W. E. Singer Ditch
No 2261
Branch

561 Rod of open ditch cleaning pluss bridges and culverts

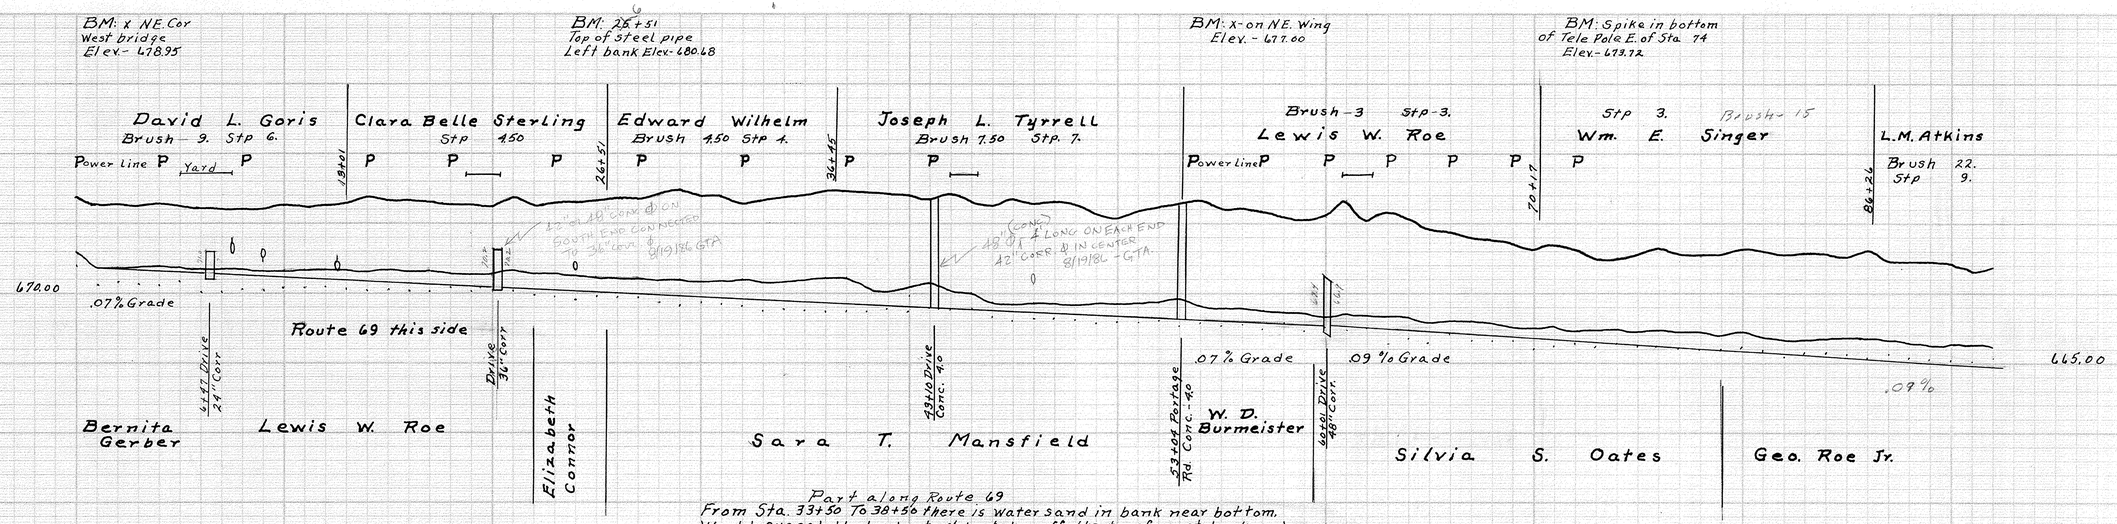
Part along Route 69
From Sta. 33+50 To 38+50 there is water sand in bank near bottom.
Would sugest that about 4' be taken off the top of west bank and leveled about 100' west of ditch and a bank slope of 2½ to 1 be used and this dirt taken back in the field and leveled.
Other than a pipe what is the answer 9-2-66

Notice This when next cleaned
